Access Compliance Report

Public Rights-of-Way

Intersection ID: 42734	Main Street: GRIER_SPRINGS_LN	Cross Street: CALDWELL_FOREST_DR	Location: S
ADA ID: D3781439A1D1	Ramp Type: PerpDiag	Initial Pass/Fail: Fail	Overall Compliance: No
Codes/Mitigation Info/Possible Solution		Field Measurements/Component Compliance

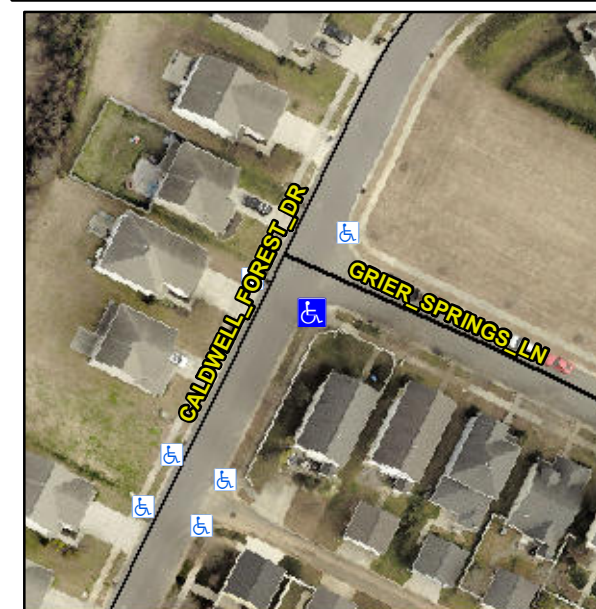
Not Found, R304.5.1, R304.2.2, R304.5.3

Compliance	Description	Data	Compliance	Description	Data
N/A	Ramp Length (in)	54.0	No	Ramp Slope (%)	8.5
No	Ramp Width (in)	32.0	No	Ramp XSlope (%)	5.0
N/A	Flare Type LT	N/A	N/A	Flare Type RT	N/A
N/A	Flare Slope LT (%)	N/A	N/A	Flare Slope RT (%)	N/A
N/A	Flare Traversable LT?	N/A	N/A	Flare Traversable RT?	N/A
N/A	Landing Length (in)	N/A	N/A	DWS Provided?	N/A
N/A	Landing Width (in)	N/A	N/A	DWS Contrast?	N/A
N/A	Landing Slope (%)	N/A	N/A	DWS Length (in)	N/A
N/A	Landing X Slope (%)	N/A	N/A	DWS Full Width?	N/A
N/A	Landing Curb? (Y/N)	N/A	N/A	DWS Offset (in)	N/A
N/A	Shared Landing?	N/A			
N/A	Gutter Ponding?	N/A	N/A	Gutter Slope (%)	N/A
N/A	Gutter Lip Ht (in)	N/A	N/A	Gutter X Slope (%)	N/A
N/A	Painted X Walk1?	No	N/A	Painted X Walk2?	No
	X Walk 1 Direction	To N		X Walk 2 Direction	To W
N/A	X Walk 1 Width (in)	N/A	N/A	X Walk 2 Width (in)	N/A
	X Walk 1 Slope (%)	3.7		X Walk 2 Slope (%)	0.7
	X Walk 1 X Slope (%)	5.2		X Walk 2 X Slope (%)	3.3

Remove & Replace Curb Ramp With Two New Directional Ramps or Equivalent.
